**COAL ASH IMPOUNDMENT
SITE ASSESSMENT DRAFT REPORT**

**Duck Creek Power Station
Ameren Energy Generating Company
Canton, Illinois**

KLEINFELDER PROJECT NUMBER 112618-5

September 16, 2010

TYPICAL EMBANKMENT SECTION - FLY ASH POND 1
NTS

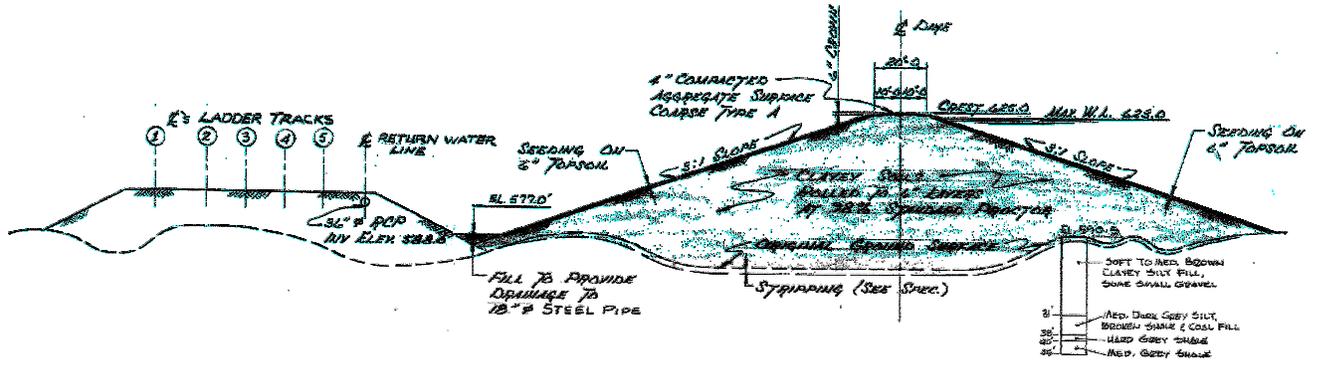
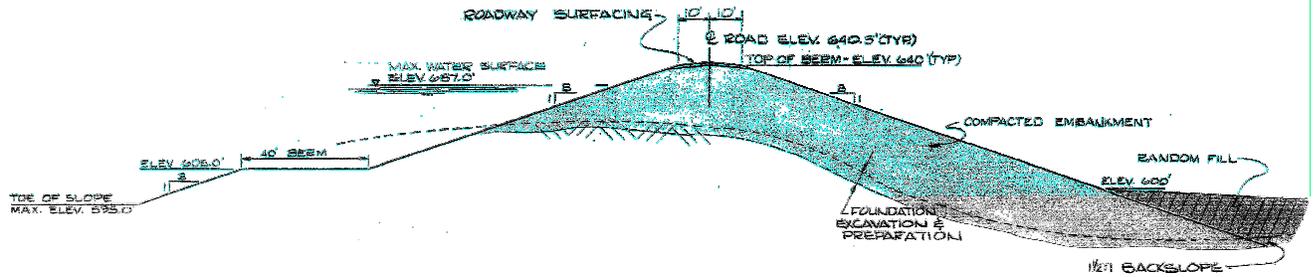
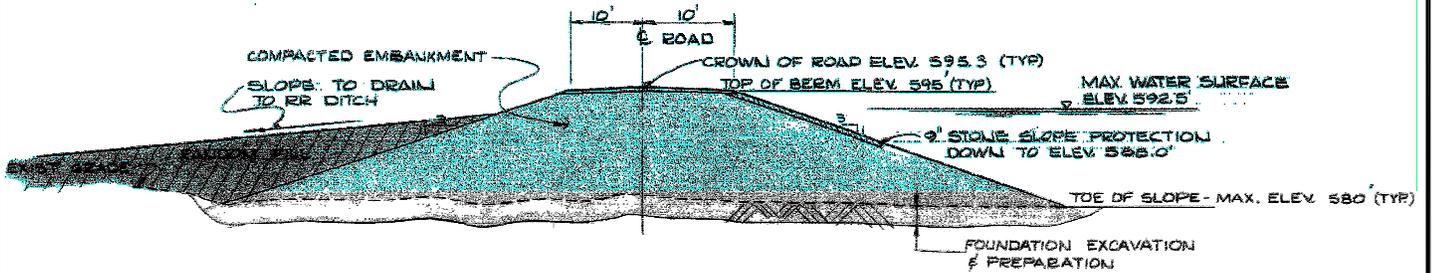
Fly Ash Pond Number 1 is somewhat unique at this site because the fly ash is generally stacked to a higher elevation within the impoundment compared to the embankment crest elevation at the perimeter. Relatively narrow drainage channels are located between the crest and the stacked flyash on the interior. If a significant precipitation event occurs, there is some uncertainty whether the runoff from the stacked ash can be accommodated in the perimeter channels without overtopping the impoundment.

Kleinfelder reviewed a report dated January 1985 by Gilbert/Commonwealth Incorporated, which was completed as part of the design for Fly Ash Pond Number 2. The study included stability analyses for a steady seepage condition with seismic loading in the pseudo-static analyses. We understand that embankment stability analyses are currently being completed for both fly ash impoundments by another consultant retained by Ameren Energy.

The structural components of the outlet works for Fly Ash Pond Number 2 have been removed and a temporary system of stacked metal pipe risers is presently being used for dewatering of the pond. This temporary inlet structure is located in the northeast corner of Fly Ash Pond Number 2 at an elevation of approximately 612 feet. This inlet structure then connects to the 36-inch reinforced concrete pipe (RCP) at an invert elevation of approximately 600 feet, which is approximately 124 feet from centerline of eastern embankment on Fly Ash Pond Number 2. The RCP then travels west to east through the east levee embankment. For the portion of the RCP that passes through the east embankment, seepage cutoff rings are present. At approximately 244 feet east from the inlet drop structure, the RCP turns and continues south for approximately 2/3 miles. Based on provided as-built drawings, the RCP ranges in depth from 3 to 10 ½ feet below grade for its entire length. No calculations were available to review for pipe flexibility, settlement, or strength design. Unless the pipe is filled and decommissioned soon, further structural analysis should be made, including RCP strength design, flexibility design, and a settlement analysis based on a seismic event. During our site visit, it was not possible to see the condition of this RCP. Video surveillance methods should be investigated to determine, if the concrete condition of the RCP is adequate.
